Agnico Eagle Mines Ltd.'s Whale Tail Pit Project

Nunavut Water Board Public Hearing

Indigenous and Northern Affairs Canada's Roles and Responsibilities

Review Comments Specific to 2AM-WTP----

Arcadis, 2016

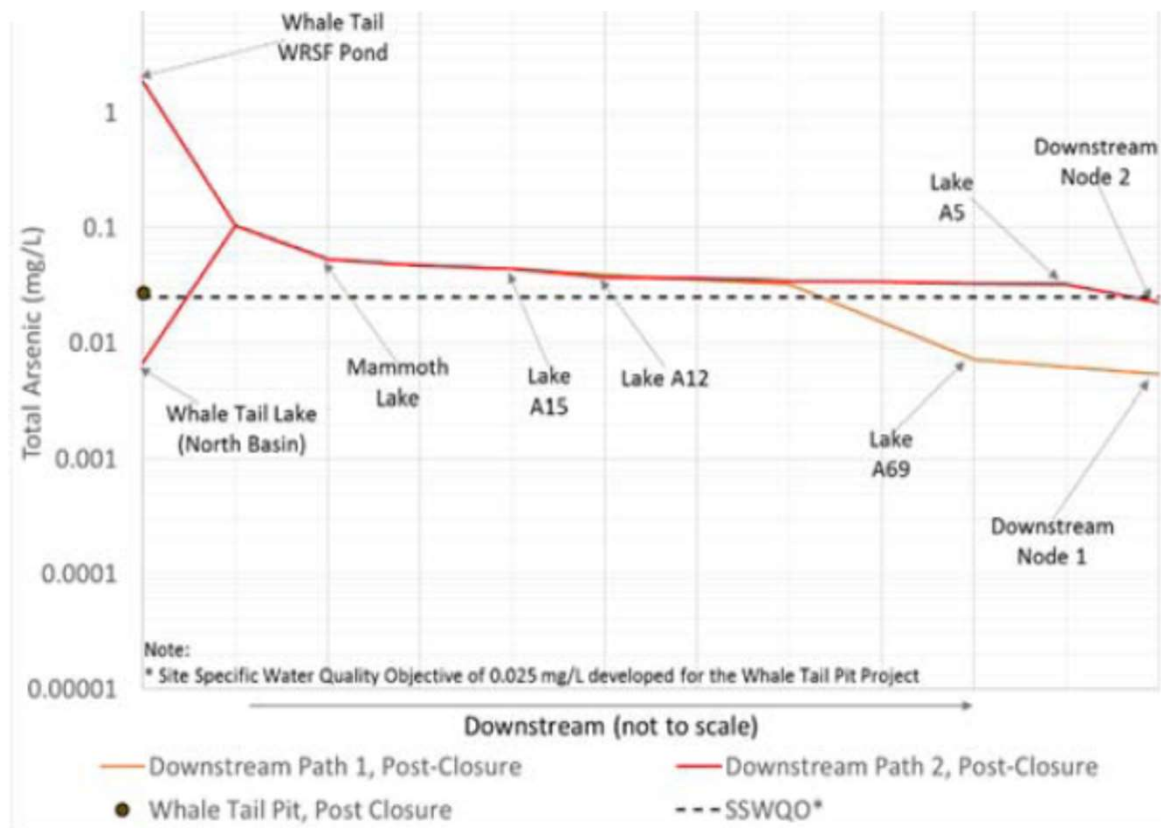
Water Quality Concern 1: Post-closure Seepage from the Waste Rock Storage Facility (INAC Final Comment #1)

- Seepage from the waste rock encapsulated in the Waste Rock Storage Facility (WRSF) will occur from the active freeze/thaw zone, with the potential to impact nearby waterbodies.
- Agnico Eagle Mines (AEM) based the modelling of this seepage on the assumption that the material used in the WRSF cover would not be arsenic leaching.
- INAC requested that AEM model the water quality of seepage receiving water bodies with 2% and 5% arsenic leaching material included in the WRSF cover to examine impacts related to less than perfect segregation of cover material.
- Modelling predicts periodic exceedance of water quality objectives for arsenic if a low amount of arsenic leaching materials included in the WRSF cover.
